Access Compliance Report

Public Rights-of-Way

(Curb Ramps)

Intersection ID: 23663	Main Street: S_TRYON_ST	Cross Street: ERWIN_RD	Location: NW
ADA ID: DA246B262E62	Ramp Type: Perp	Initial Pass/Fail: Fail	Overall Compliance: No
			Severity Score: 13.75

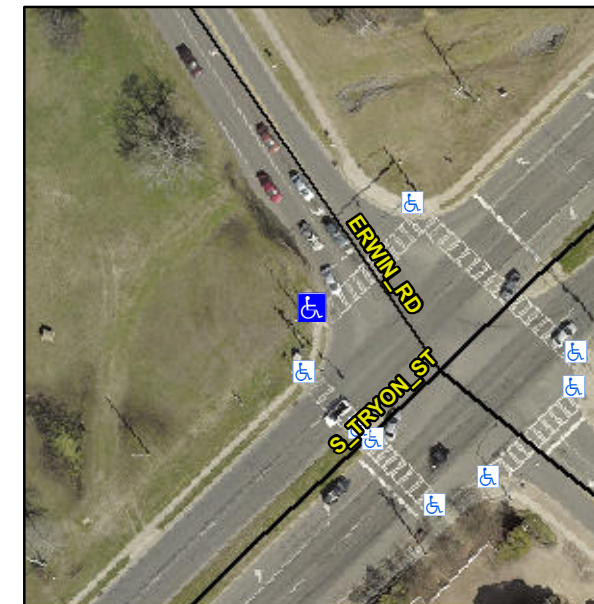
Not Found, R304.2.2, R304.5.3

Compliance	Description	Data	Compliance	Description	Data
N/A	Ramp Length (in)	90.0	No	Ramp Slope (%)	8.5
Yes	Ramp Width (in)	48.0	No	Ramp XSlope (%)	2.3
N/A	Flare Type LT	N/A	N/A	Flare Type RT	N/A
N/A	Flare Slope LT (%)	N/A	N/A	Flare Slope RT (%)	N/A
N/A	Flare Traversable LT?	N/A	N/A	Flare Traversable RT?	N/A
N/A	Landing Length (in)	N/A	N/A	DWS Provided?	N/A
N/A	Landing Width (in)	N/A	N/A	DWS Contrast?	N/A
N/A	Landing Slope (%)	N/A	N/A	DWS Length (in)	N/A
N/A	Landing X Slope (%)	N/A	N/A	DWS Full Width?	N/A
N/A	Landing Curb? (Y/N)	N/A	N/A	DWS Offset (in)	N/A
N/A	Shared Landing?	N/A			
N/A	Gutter Ponding?	N/A	N/A	Gutter Slope (%)	N/A
N/A	Gutter Lip Ht (in)	N/A	N/A	Gutter X Slope (%)	N/A
N/A	Painted X Walk1?	Yes	N/A	Painted X Walk2?	N/A
	X Walk 1 Direction	To NE		X Walk 2 Direction	N/A
N/A	X Walk 1 Width (in)	120.0	N/A	X Walk 2 Width (in)	N/A
	X Walk 1 Slope (%)	2.5		X Walk 2 Slope (%)	N/A
	X Walk 1 X Slope (%)	0.4		X Walk 2 X Slope (%)	N/A

Remove & Replace Entire Ramp.
